## Town of Kittery Planning Board Meeting July 13, 2023

#### ITEM 4 – 21 Badgers Island West–Shoreland Development Plan Review

#### APPLICATION & PLAN REVIEW

SHORELAND **DEVELOPMENT PLAN**

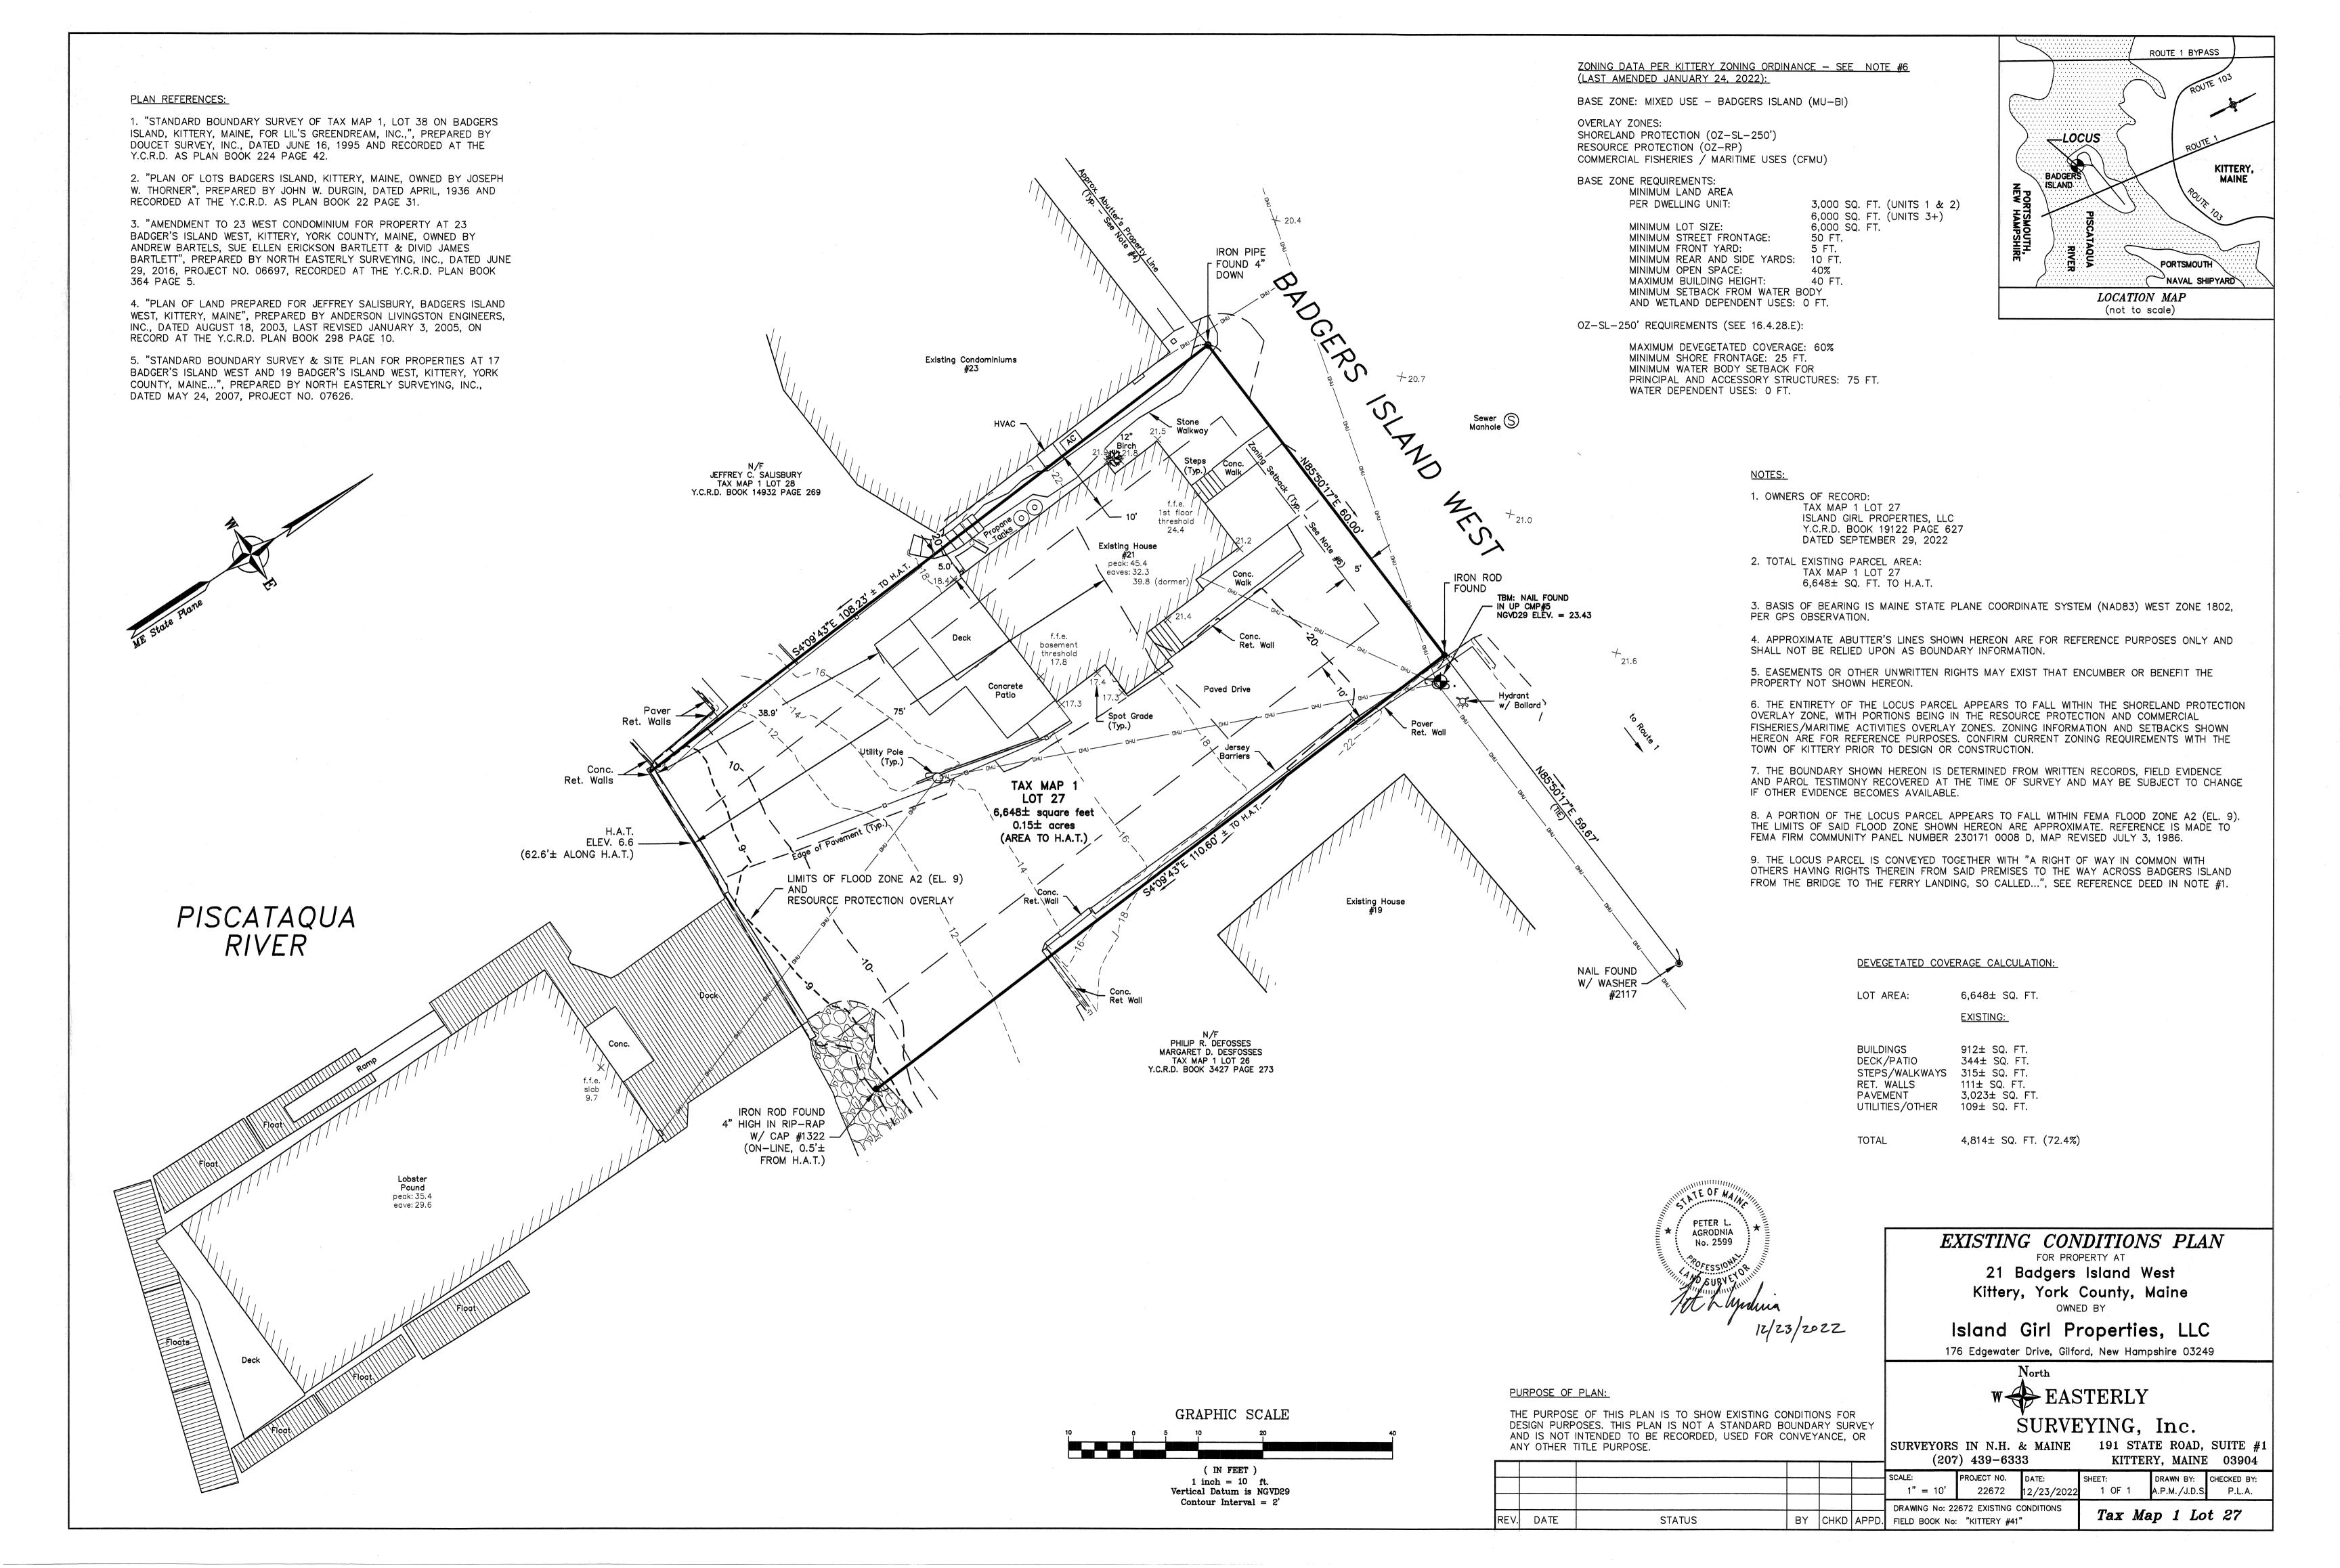
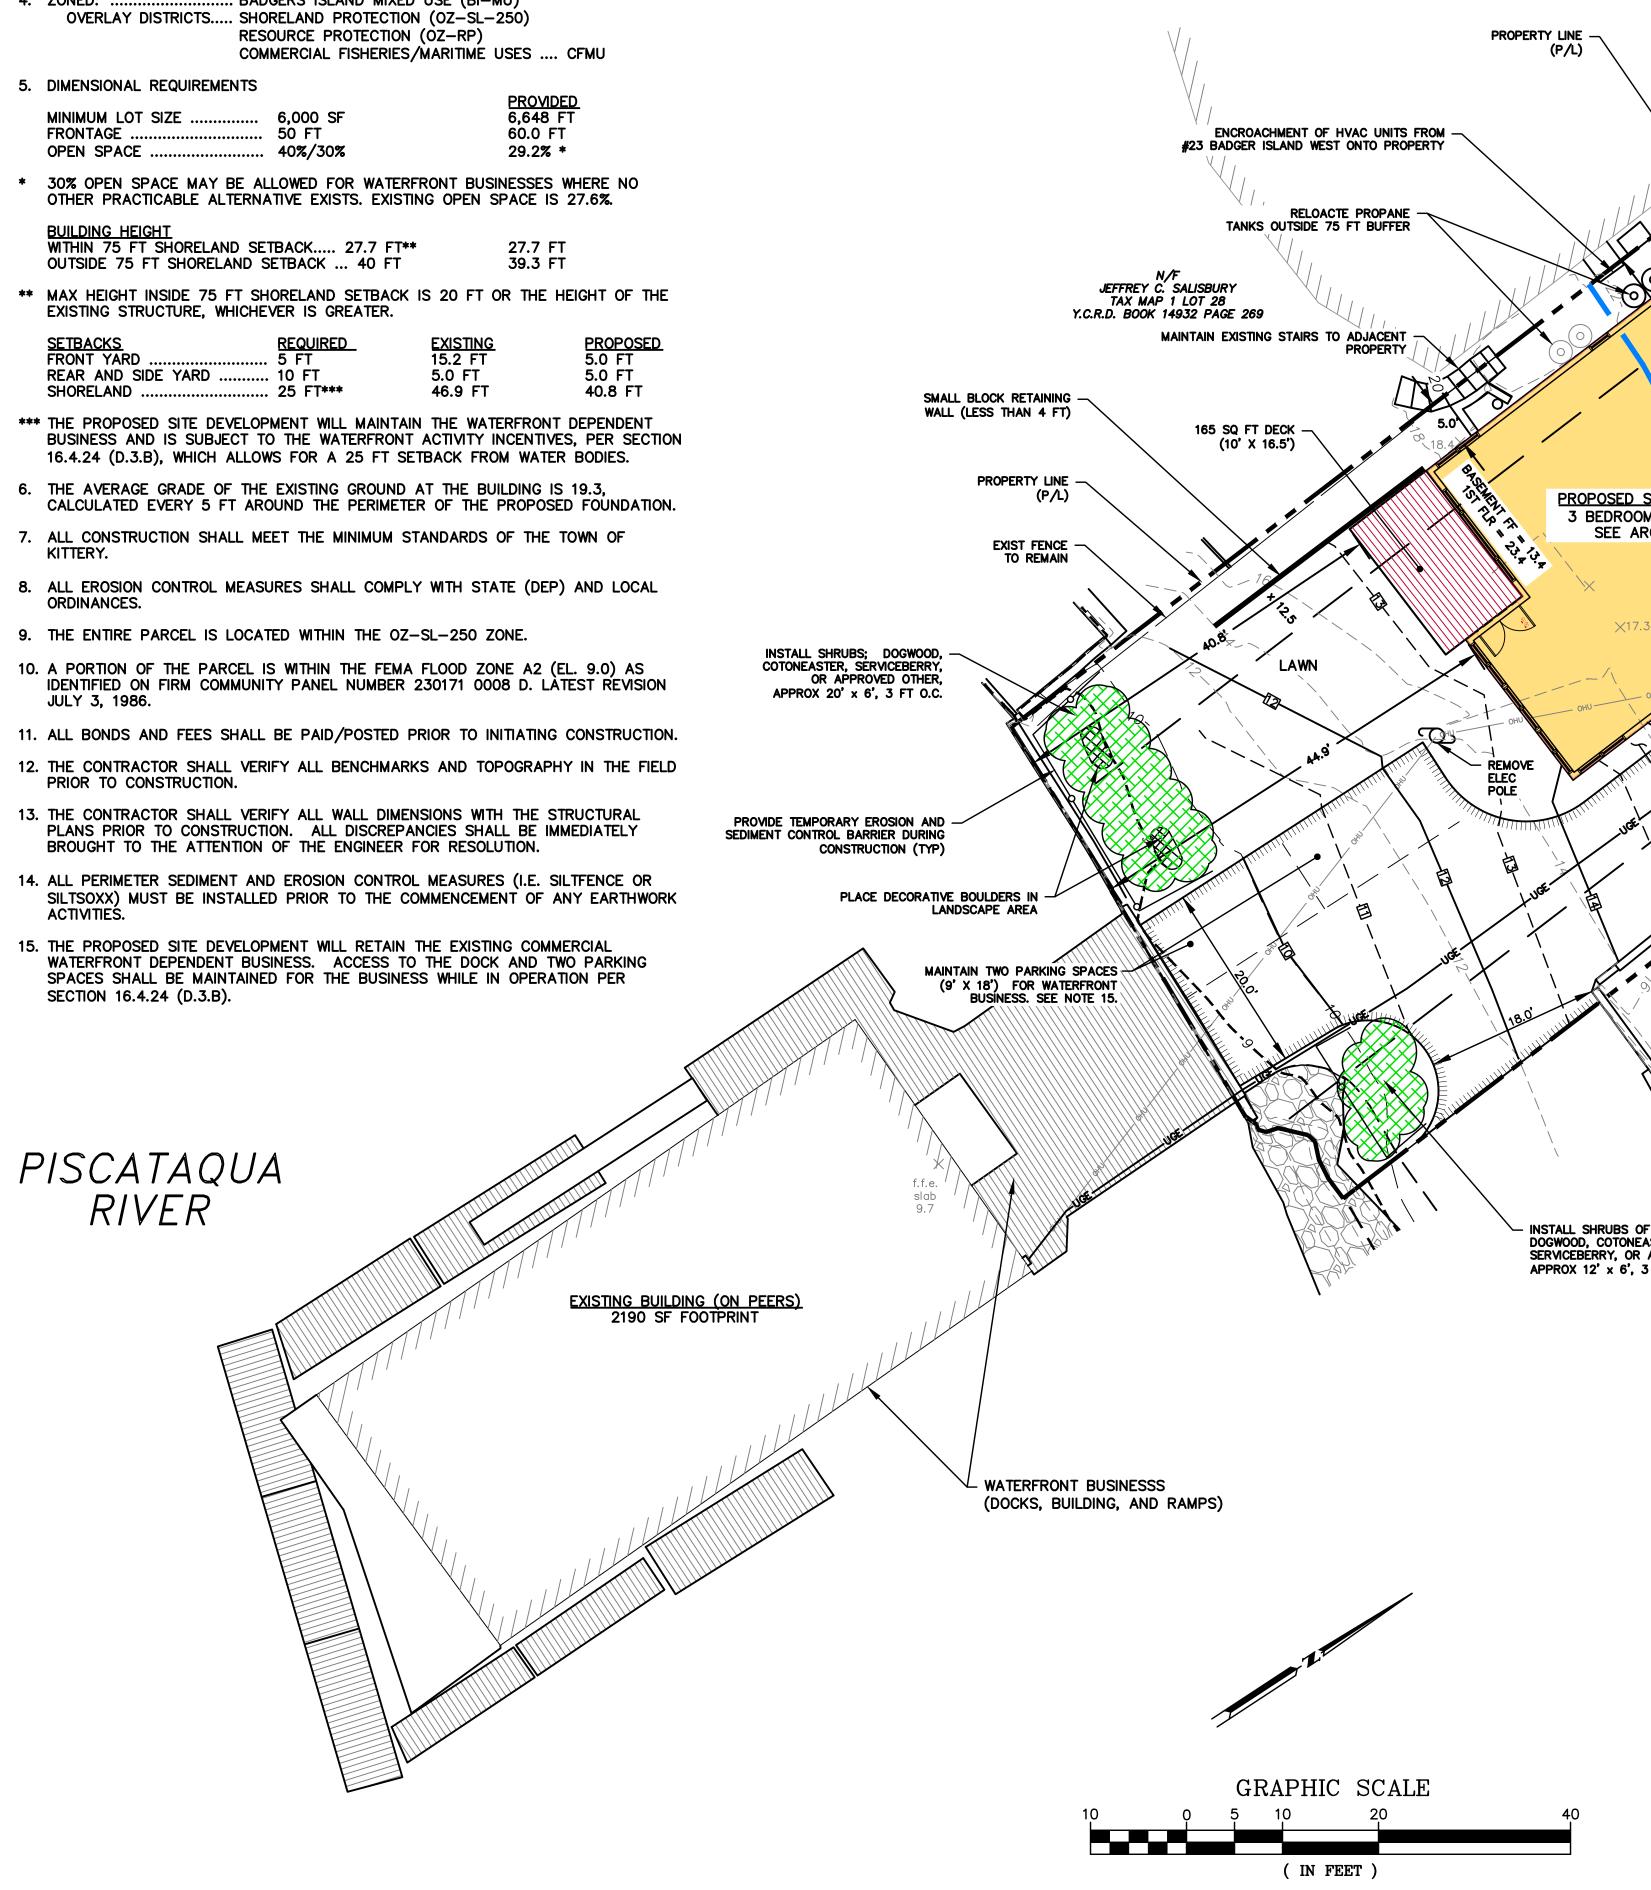
- 3. **§16.4.28.E.(2).(a).** allows 60% of total lot area in the Mixed-Use Badgers Island zone's shoreland overlay to be comprised of non-vegetated surfaces or structures. With a lot size of 6,648 sq ft, current devegetation sits at 4,814 sq ft, or 72.4%. The proposed development would reduce non-conformity by lowering the total devegetated area to 4,668 sq ft, or 70.2%.

- a. The notes on the site plan's devegtetation calculation only add up to 4,646 sq ft, do to an accidental omission of a granite stairway totalling 22 sq ft. The applicant confirmed 4,668 sq ft. is the correct number.
